ADDENDUM 1

ALASKA DEPT. OF FAMILY & COMMUNITY SERVICES
JUNEAU PIONEERS HOME
COURTYARD RENOVATIONS
PROJECT NO.: ANC 24-43C

**SITE PLAN
BASE BID**

E3.0

1 SITE PLAN - BASE BID
SCALE: 1" = 15'

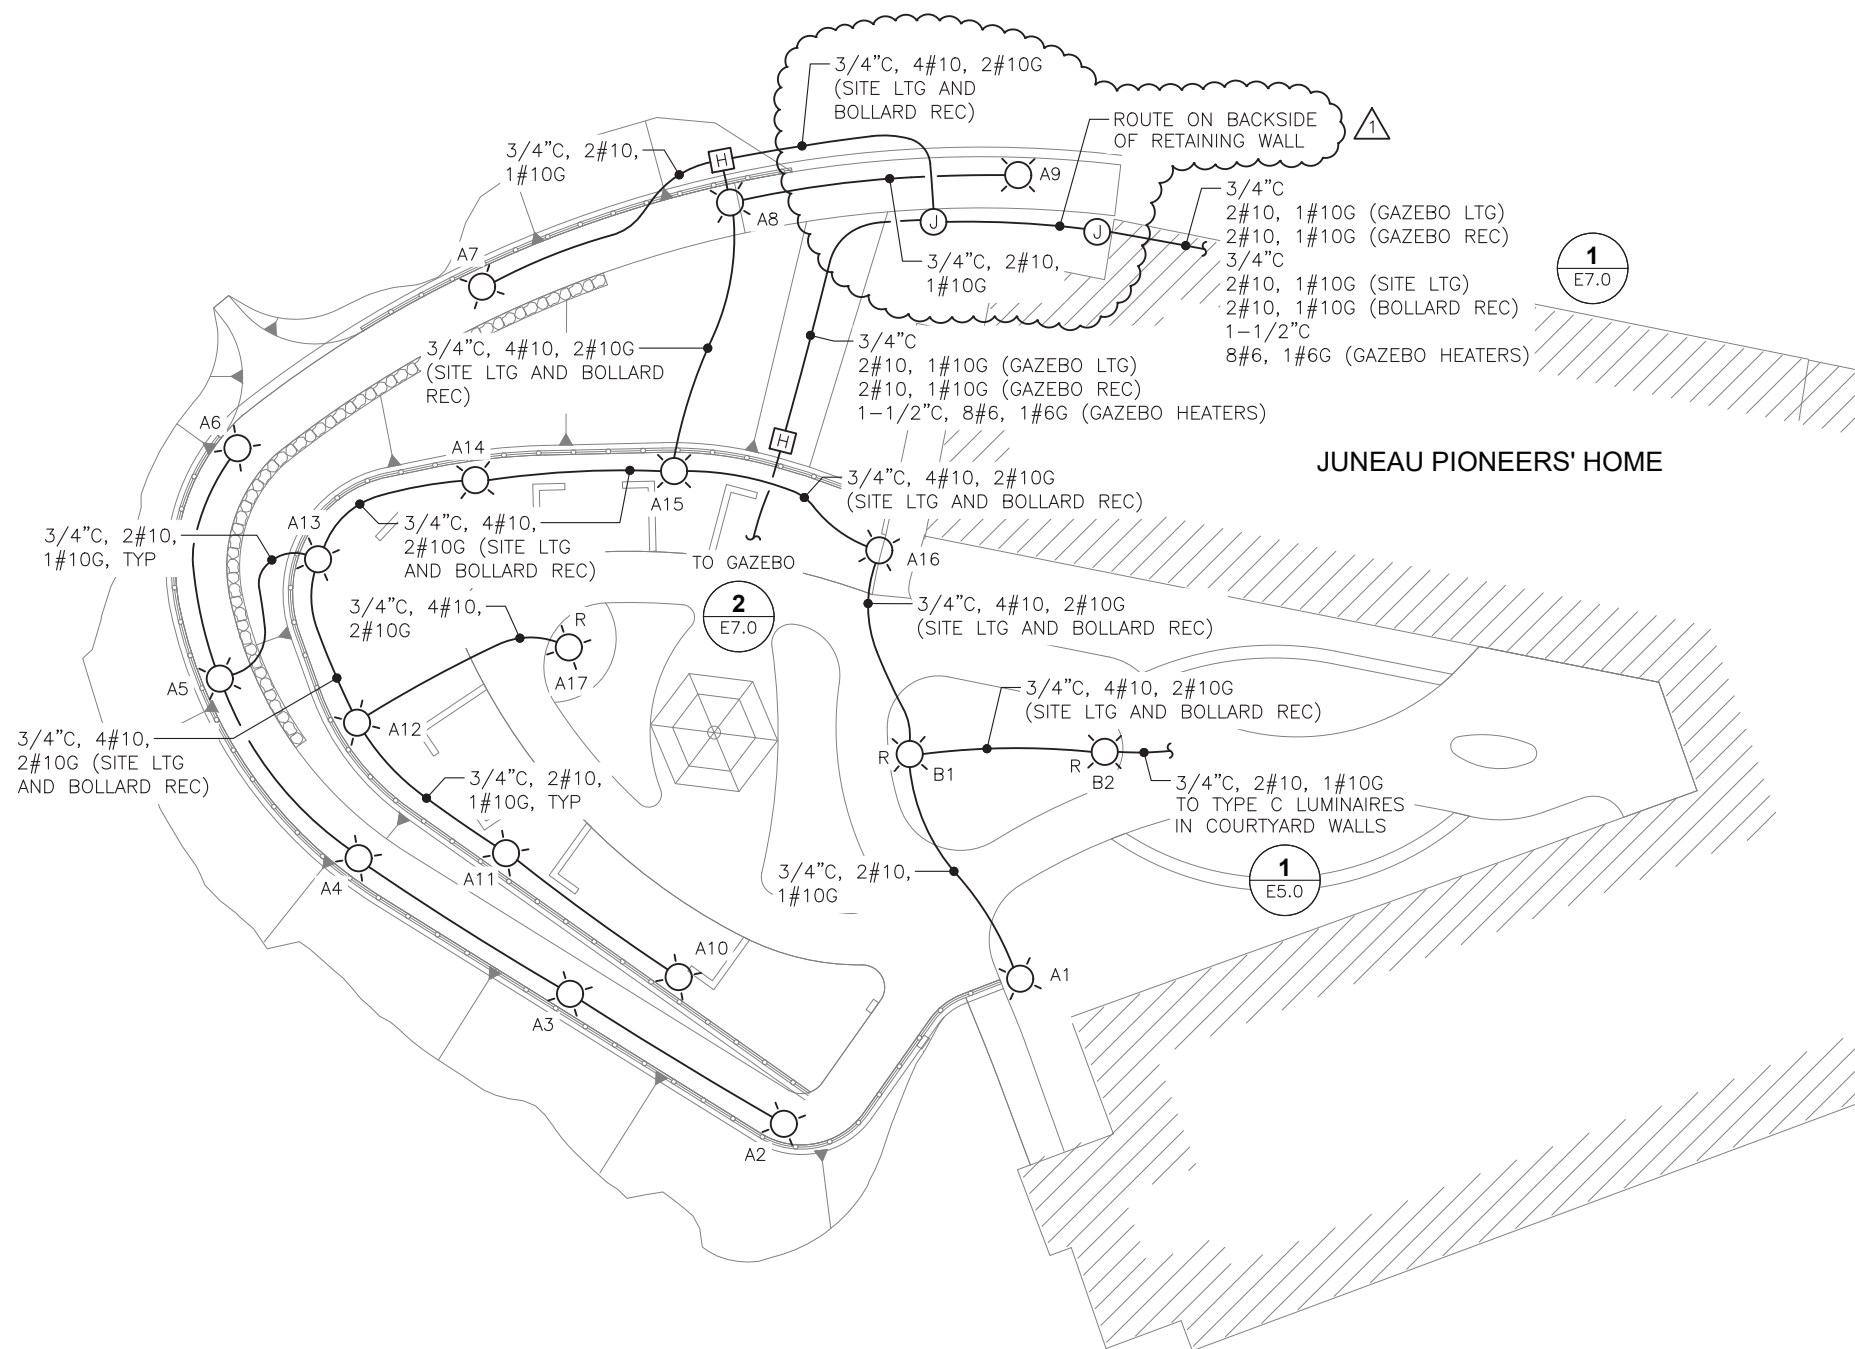
REVISIONS					
REV.	DATE	DESCRIPTION	DWN.	CKD.	APP.
1	6/28/24	REVISE CONDUIT ROUTE AT RETAINING WALL	BJB	BJB	BJB
